Meeting: **April 23, 2019**  
Project: **Casalini Warehouse**  
Planner: Courtney McNair

### i. **CONDITIONAL USE PERMIT REQUEST**

### ii. **PRELIMINARY LARGE SCALE DEVELOPMENT PLAN APPROVAL**

**Re: Large Scale Development and Conditional Use  
Caslini Warehouse Building  
CDE Project No. 1123**

DRAWING:  
A3.1  
EXTERIOR BUILDING  
ELEVATION(S)

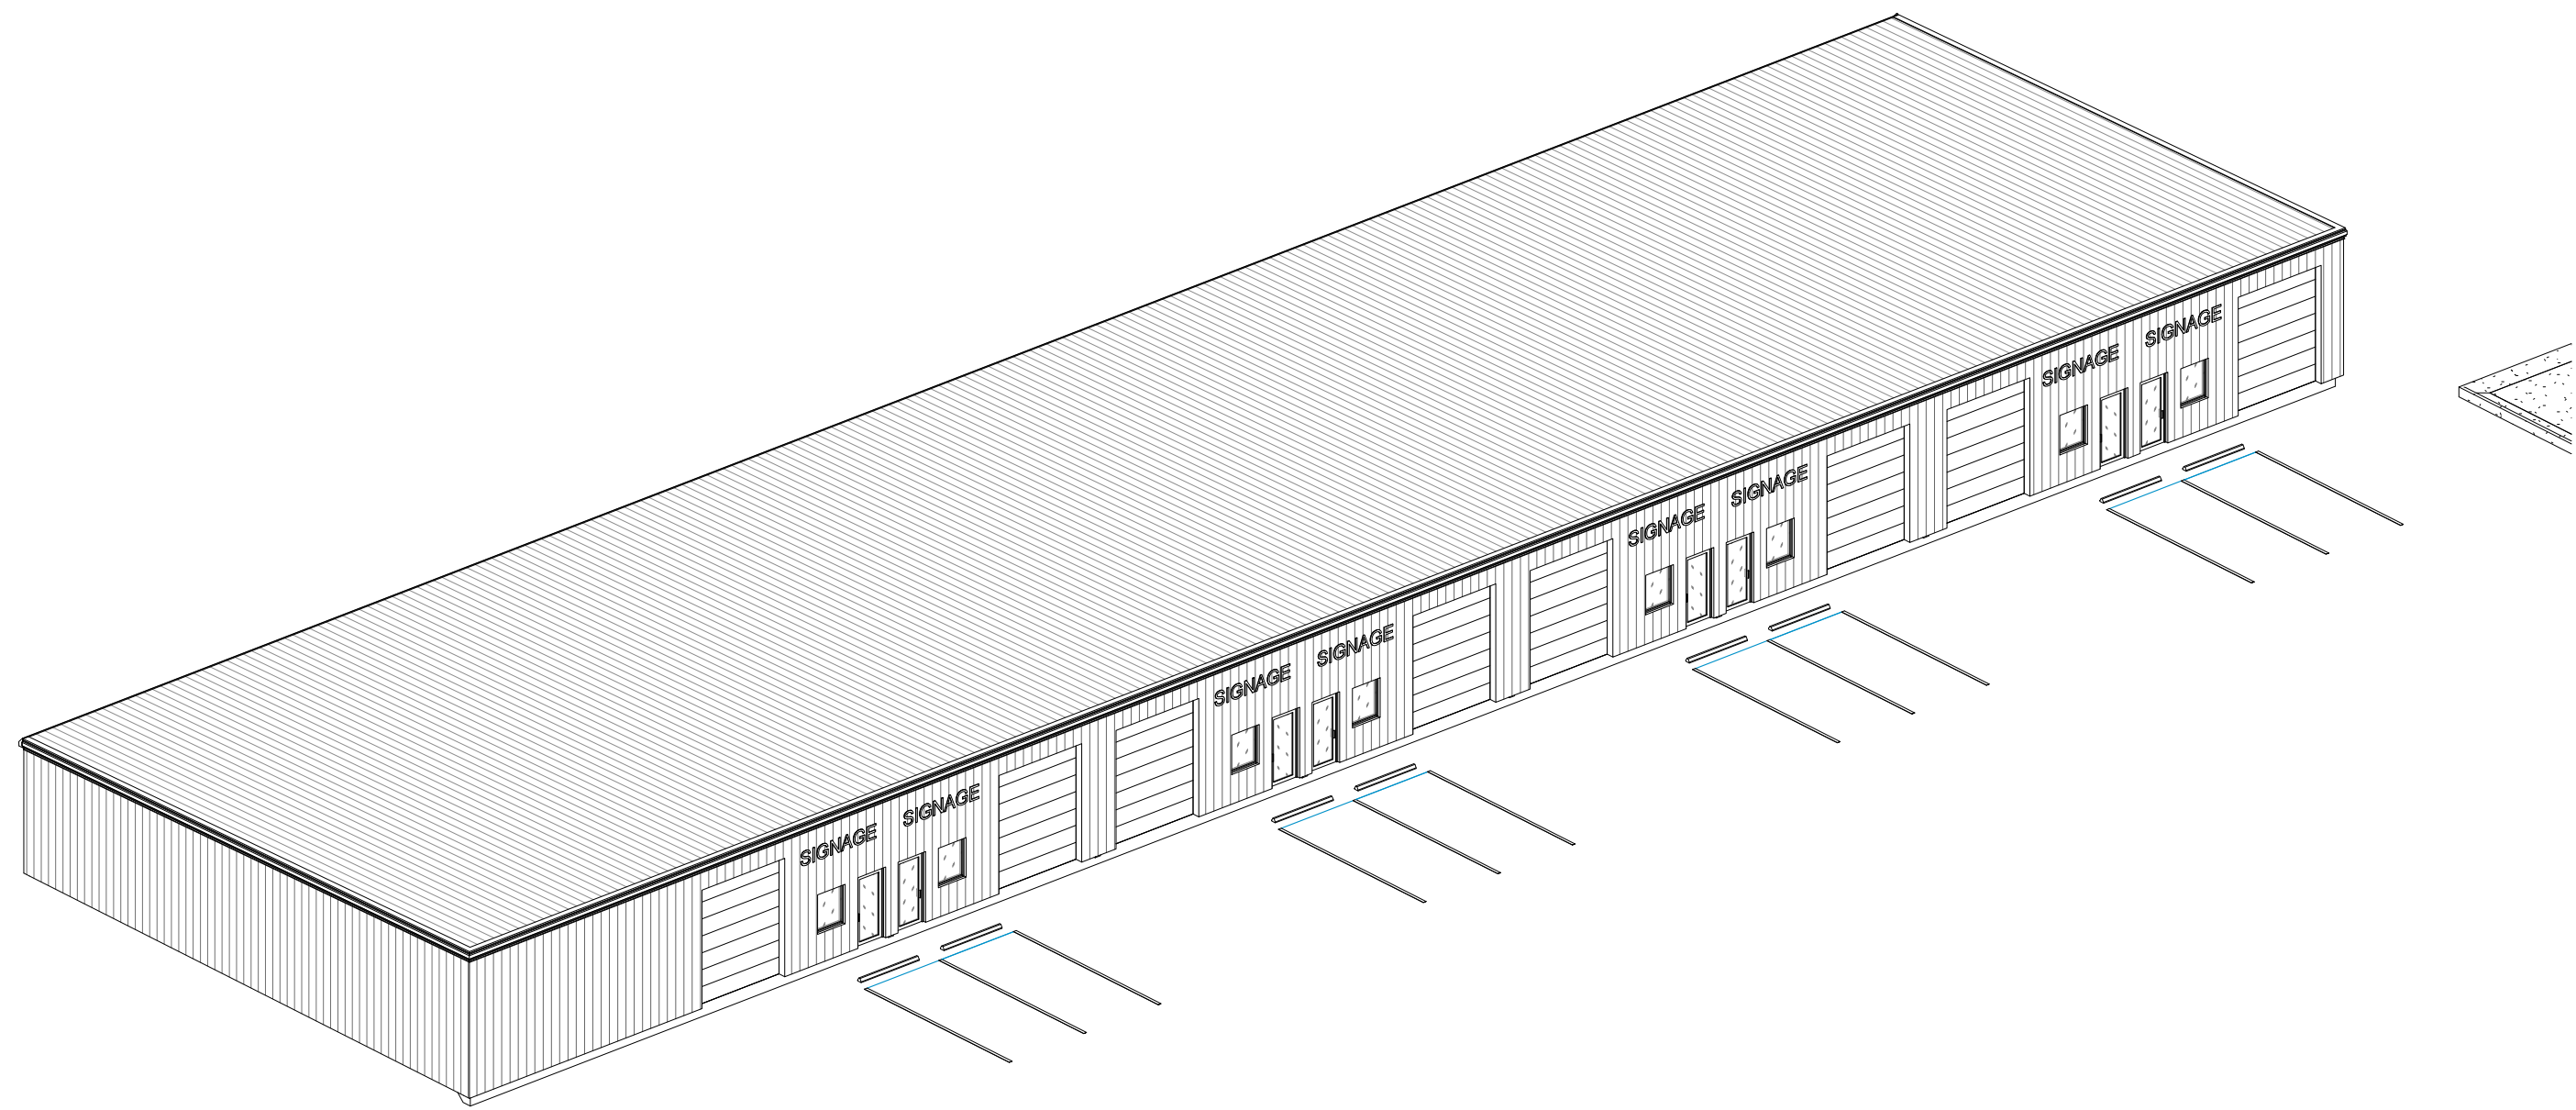
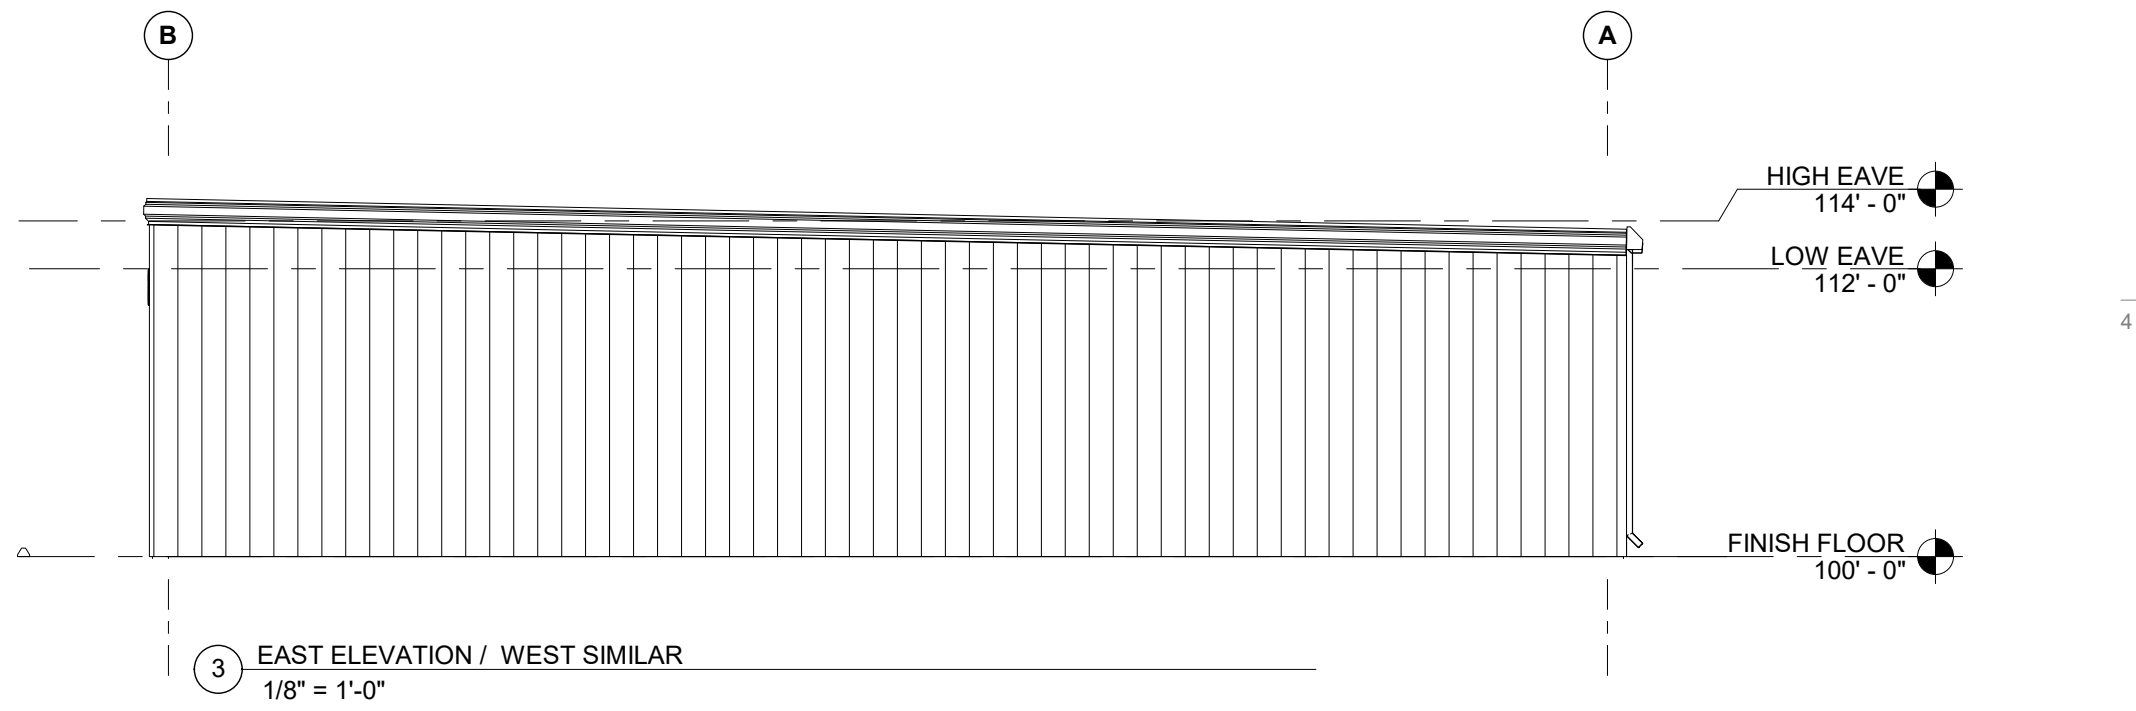
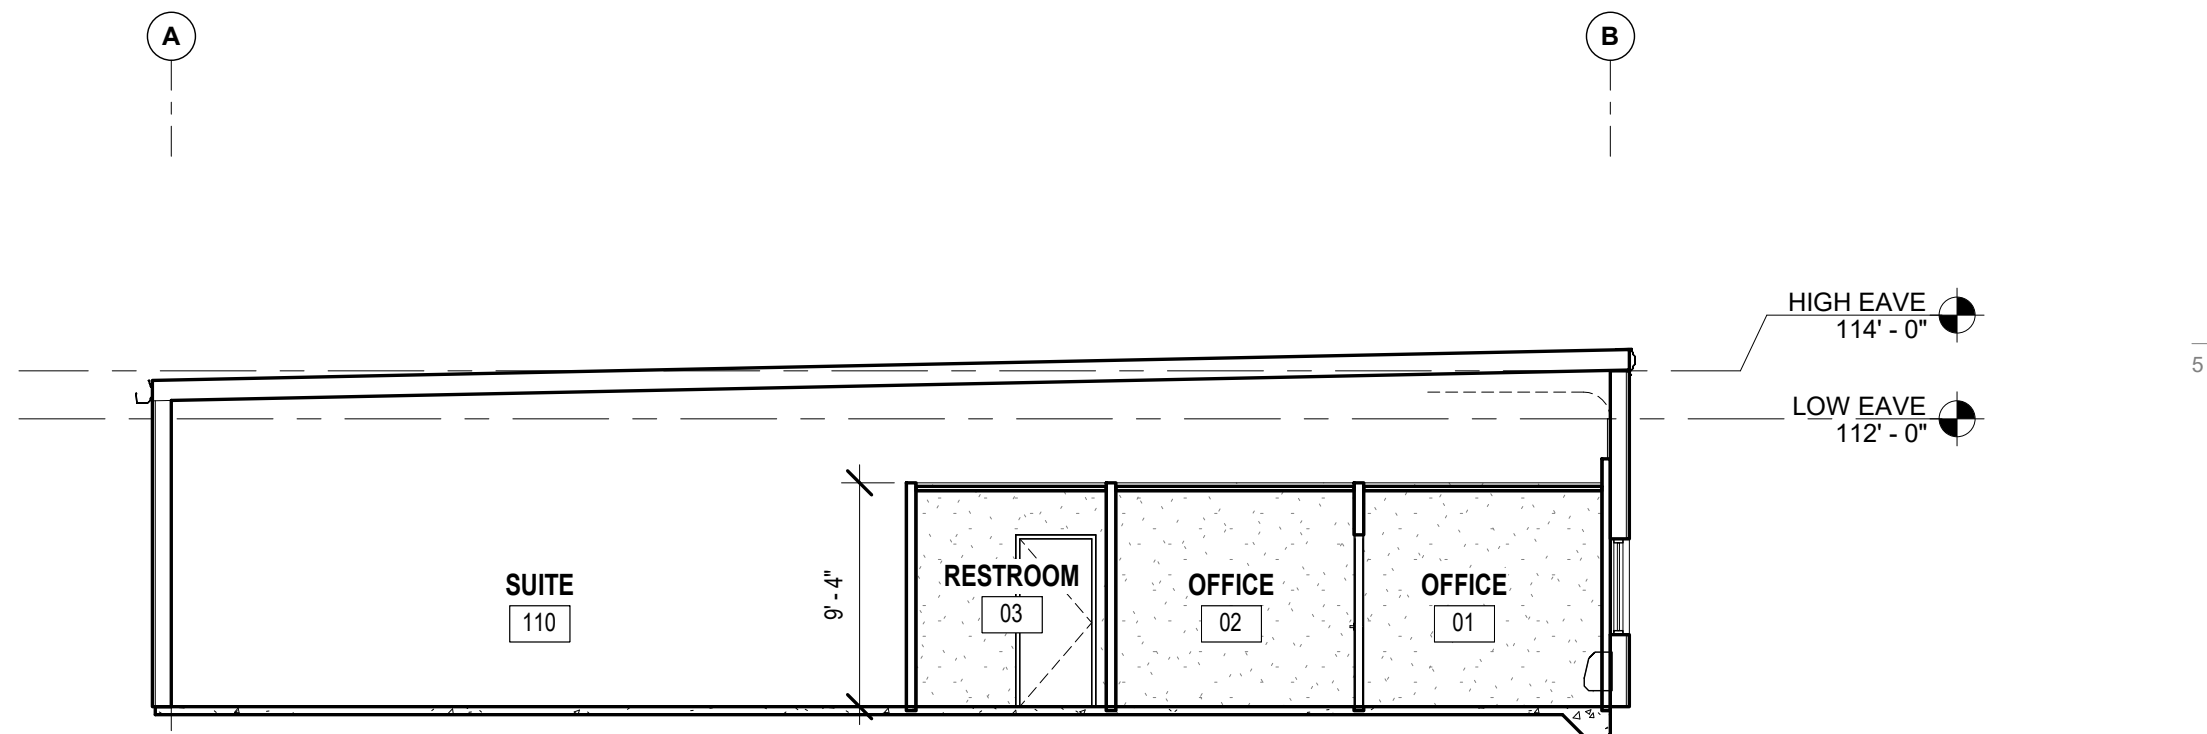
Architectural elevations were submitted. They do not show compliance with the Large-Scale Development standards; however, a letter was submitted addressing this issue. All facades facing N. Maestri shall be in compliance with these standards.

Also, as discussed in our meeting, we will propose a brick façade along the west exterior wall of the building since it could be visible from N. Maestri Rd (US Highway 112). Architectural drawings will be updated to reflect this as part of the Building Permit submittal.
